# Environmental Impact Assessment

## Schedule III

<b>ERA Reference no.:</b>	EA/0053/18
<b>PA Reference no.:</b>	PA 01384/18
<b>Project Title:</b>	Proposed Development of a 5 MW PV Farm overlying the Maghtab Landfill including related surface culverts and Four (4) new Substations
<b>Location:</b>	Maghtab Landfill, Triq ir-Ramla, Il-Maghtab, Naxxar, Malta
<b>Screening date:</b>	September 2018

**Figure 2.** Photomontages showing the proposed development (Source: PDS)

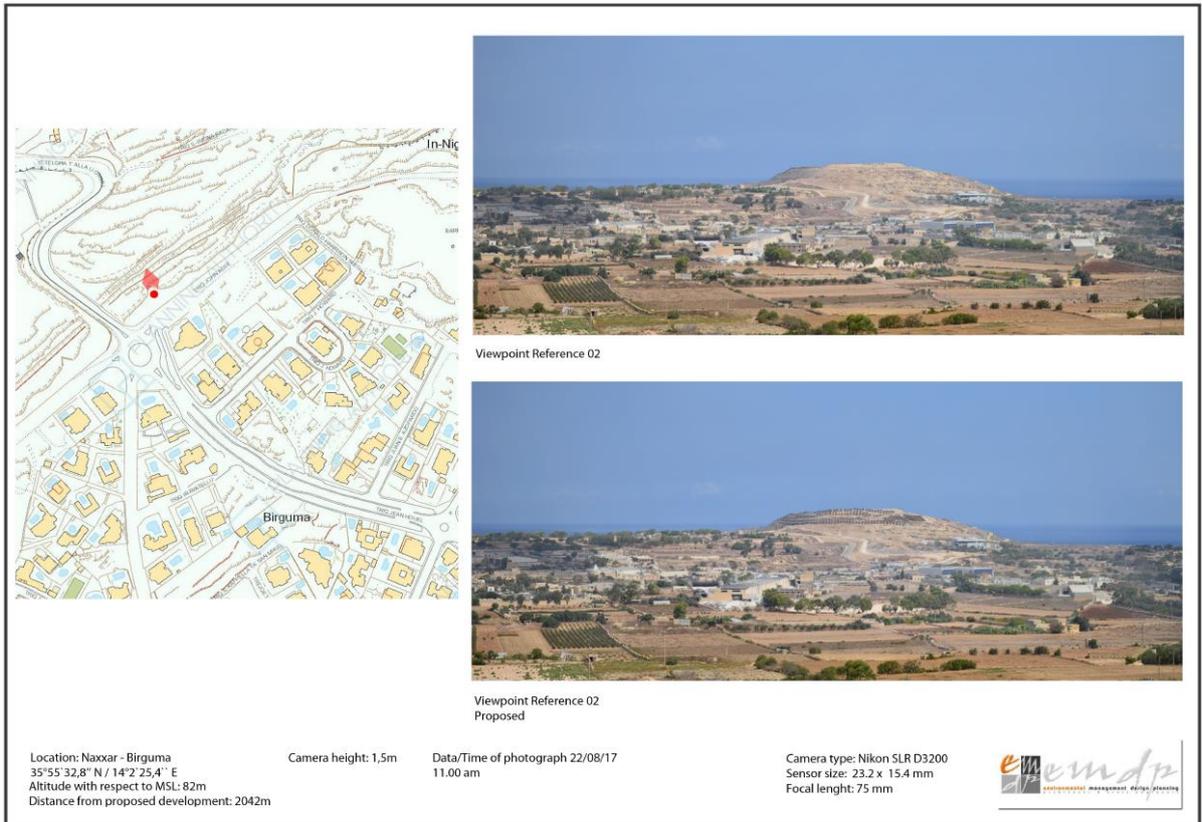
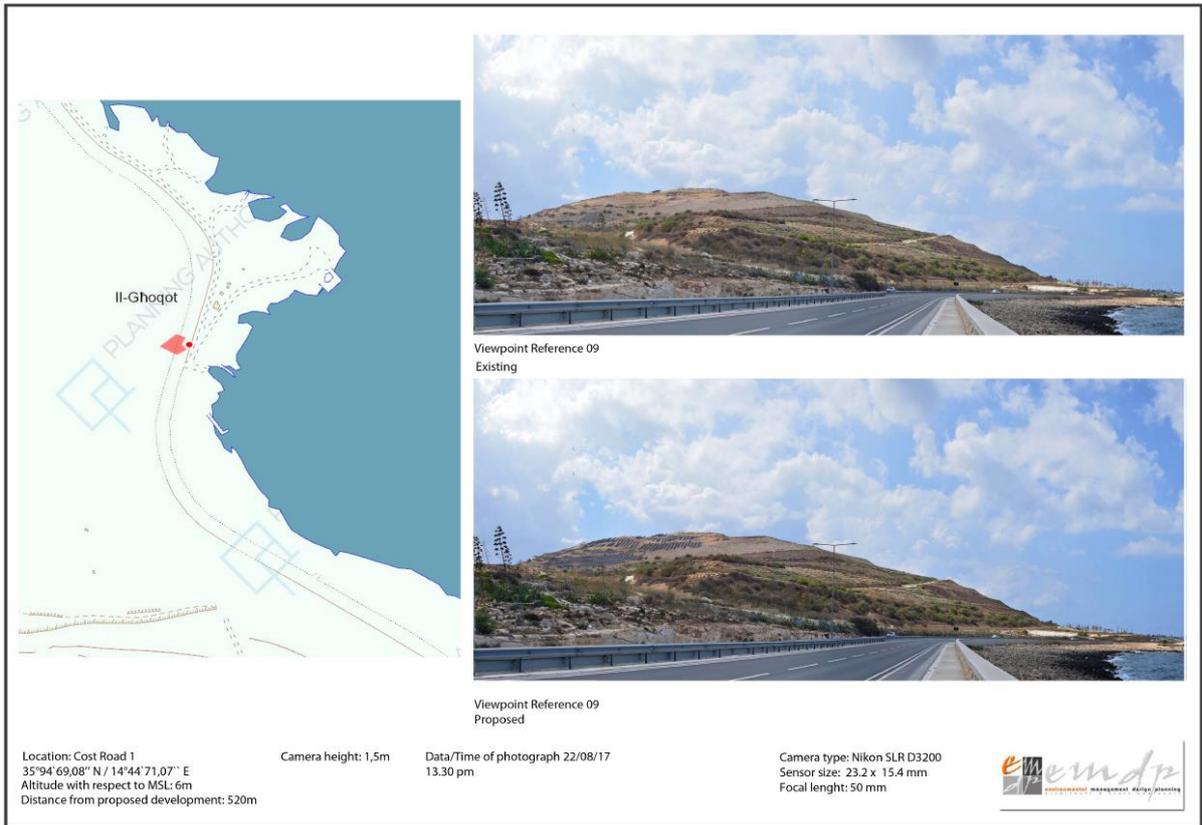
- 3.4.** The project will be highly visible by many people, and may have an impact on the visual amenity and landscape of the area. However, such an impact is unlikely to be significant relative to the current baseline which is dominated by the prominent landfill. The panels will also be installed at a specific angle to reduce light reflection, as well as using specific materials and coatings to reduce glare. This is covered by the Landscape and Visual Amenity study included as part of the PDS (See Figure 2 for photomontages of the site).
